Planning and Zoning Board

GENERAL PLAN CASE #: ZON18-00181 (Minor General Plan Amendment)
ZONING CASE #: ZON18-00067 (Re-zoning and Site Plan Review)
LOCATION/ADDRESS: The 9500 thru 9800 blocks of East Hampton Road (south side).
GENERAL VICINITY: Located north of the US-60 Superstition Freeway and west of Crismon Road.
GENERAL PLAN REQUEST: Minor General Plan amendment to change Character Type from Employment to Neighborhood-Suburban.
ZONING REQUEST: Rezone from NC-BIZ, NC-PAD and PEP-PAD-CUP to RSL2.5-PAD and RM-3-PAD, and Site Plan Review; and consideration of the Preliminary Plat for "Bella Encanta"
PURPOSE: This request will allow for a small-lot, single-residence subdivision and multi-residence development.
COUNCIL DISTRICT: District 6
OWNERS: Crismon BFC LLC
APPLICANT: Pew and Lake, PLC
STAFF PLANNER: Lisa Davis, AICP

STAFF RECOMMENDATION: Denial of the Minor General Character Amendment
Denial of Rezone and Site Plan
Denial of Preliminary Plat

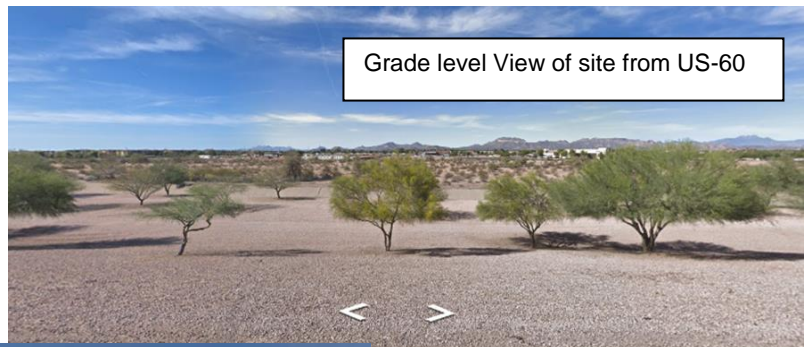
95% of the residential projects adjacent to the US-60 in Mesa have a berm or sound attenuation wall, inset to the right, between the freeway and the residential projects but that is not occurring at this

site. If a residential project were to be constructed at this site, design of the development needs to include adequate buffering from the grade level adjacent US-60 freeway. The east side of the project does propose a 15' building setback adjacent to the PEP-PAD site and a 30' setback is required. Staff is concerned with sustainability and livability for the project and is not in support of this modification.

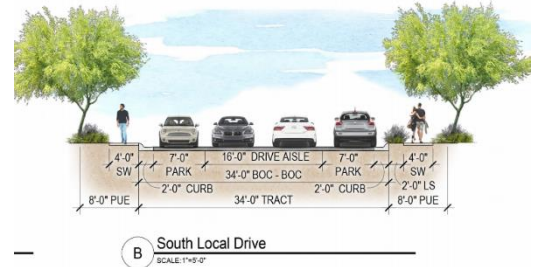
- The proximity to the US-60 Freeway, the adjacent Planned Employment Park to the east and Hampton Avenue have not been considered in the design of the project. Buffers from all have not been considered in the design.
- Solid Waste-The condominium units will have large bins for solid waste service. These bins are located adjacent to the small lot single residences and adjacent to the open space areas. The Mesa Zoning Ordinance (MZO) Section 11-30-12 provides standards for trash and refuse collection areas.

These standards include that the locations are reasonably equalized. Although the applicant shows that the bins are equally distributed, although far for the residents in the southern placed units. The placement of the bins adjacent to the small residential lots and next to the open space with residential houses and condos facing onto the areas are a concern. These areas can often become messy and unsightly. There is also concern for timing of the solid waste truck picking up the bins at 6 am adjacent to the homes. This is not a good design and is not supported by staff.
